HEARING IN THE MATTER OF
CALIFORNIA DEPARTMENT OF
WATER RESOURCES AND UNITED
STATES BUREAU OF
RECLAMATION
REQUEST FOR A CHANGE IN POINT
OF DIVERSION FOR CALIFORNIA
WATER FIX

SURREBUTTAL TESTIMONY OF
DEIRDRE DES JARDINS
(ERRATA)

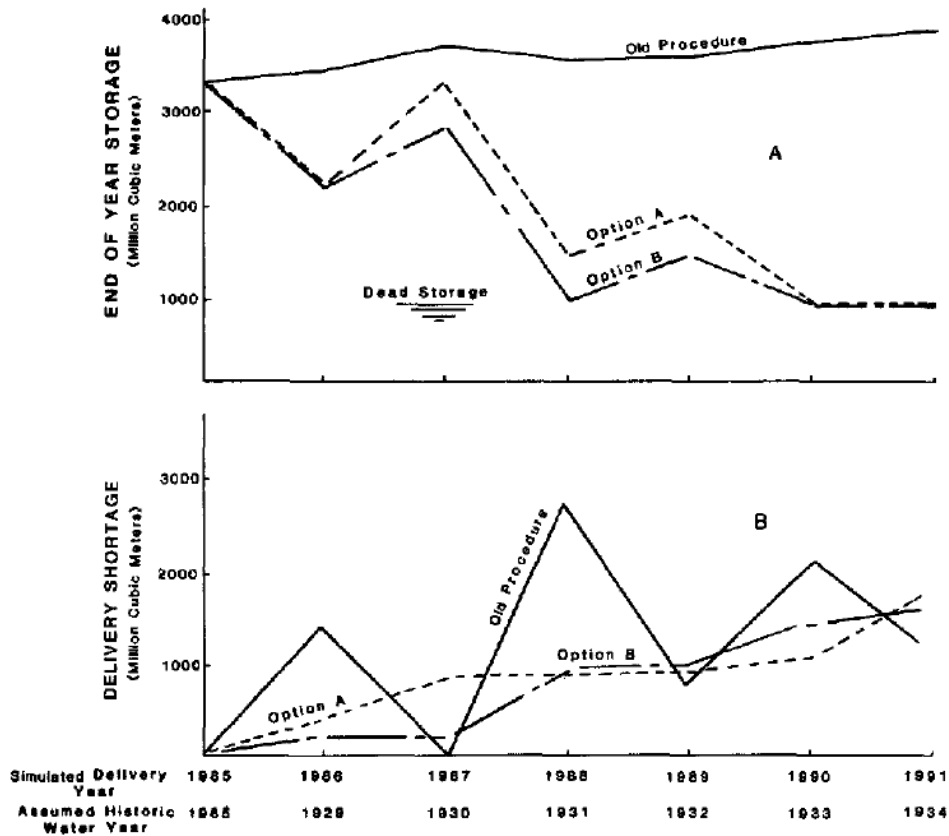
27 Bulletin 160-83 does not disclose what the specific proposed changes were to carryover storage.
28 But these changes were disclosed in a 1988 article in the academic journal Climatic Change by William

1 E. Riebsame, "Adjusting Water Resources Management to Climate Change" (Exhibit DDJ-210.)²
 2 Riebsame cited an unpublished 1985 report by DWR, "Evaluation of the State Water Project Rule Curve
 3 Procedure," and an unpublished report in 1988, "State Water Project Rule Curve for 1988." The new
 4 and old rule curves for total end of year system storage was reproduced by Riebsame on p. 84:

1 This rule curve was shown to State Water Project Chief Operator John Leahigh on cross-
2 examination in Part 1A of the WaterFix hearing. Leahigh stated in response:

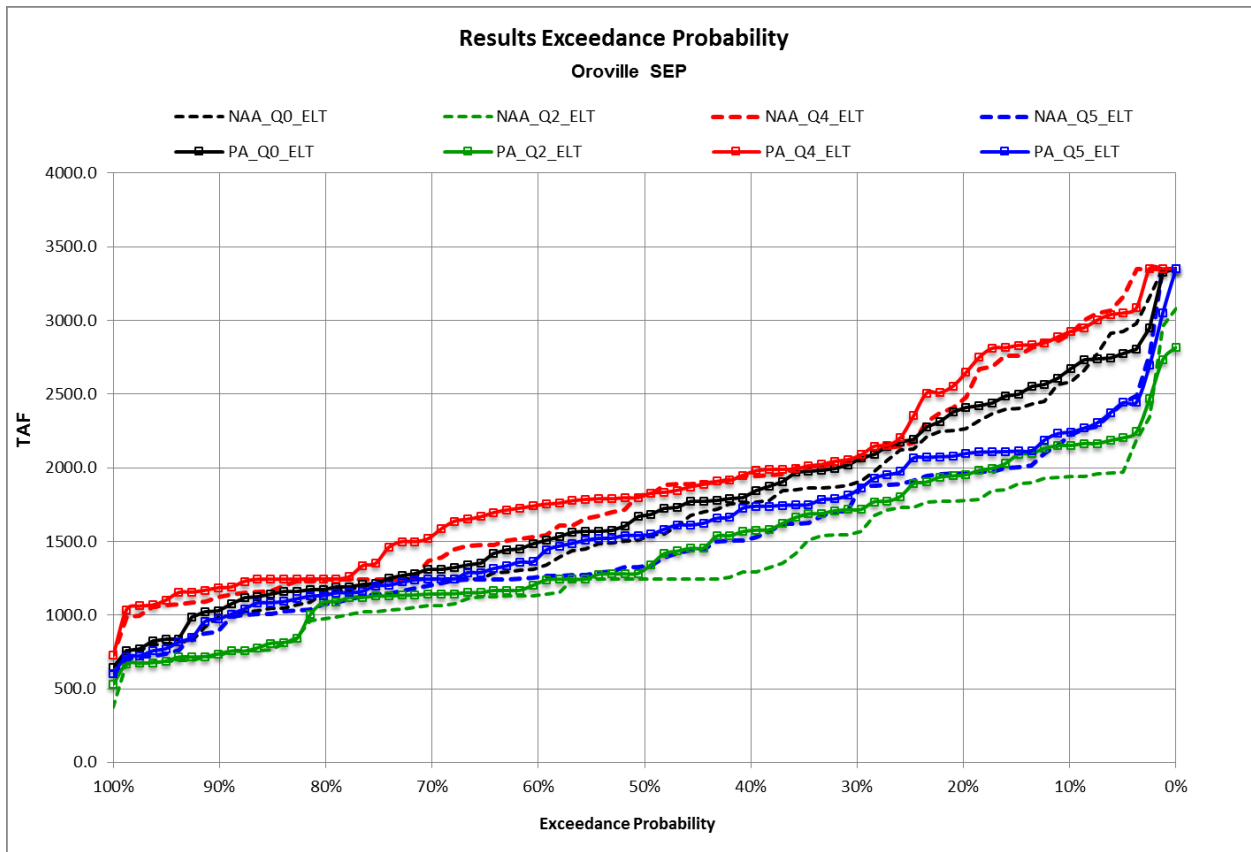
As shown on the graph on the next page from the BA, the response was to have lower End of September carryover storage in Oroville. This exacerbates the effects discussed in the preceding section. These effects will also be worse for higher sea level rise scenarios, because increased outflows are needed to repel salinity.

Estimated Relative Sea Level Change Projections From 2000 To 2135 -
Gauge: 9415144, Port Chicago, CA (2,79 mm/yr)

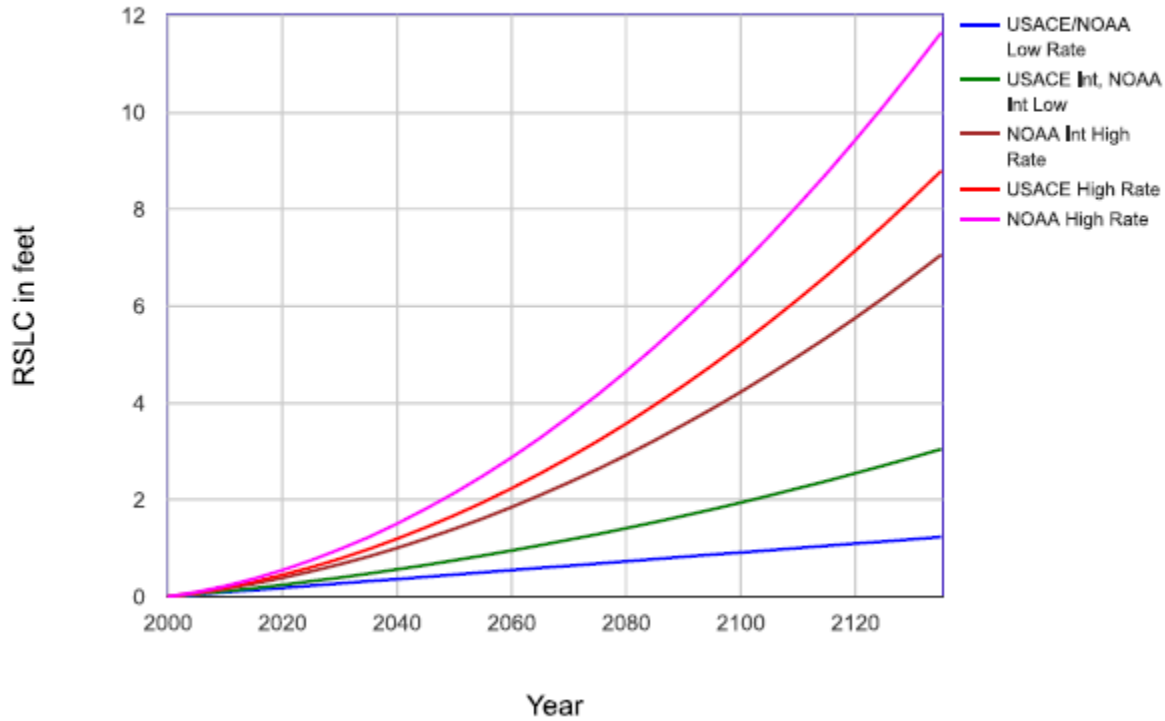
5
6 The closest NOAA tide gauge to the Delta is at Port Chicago. The USACE low, intermediate,
7 and high scenarios at the NOAA tide gauge at Port Chicago were provided in testimony in Part 1B for
8 Pacific Coast Federation of Fishermens' Associations / Institute for Fisheries Resources (PCFFA/IFR.)
9 as a graph in exhibit PCFFA-65 and a table in exhibit PCFFA-64.

10 The curves in exhibit PCFFA-65 were provided through 2135, which was the end of the
11 estimated 100 year lifetime of the project, and within the lifetime of the Change Petition. The USACE
12 intermediate and high rates of sea level rise are somewhat lower than those estimated by NOAA, but
13 similar.
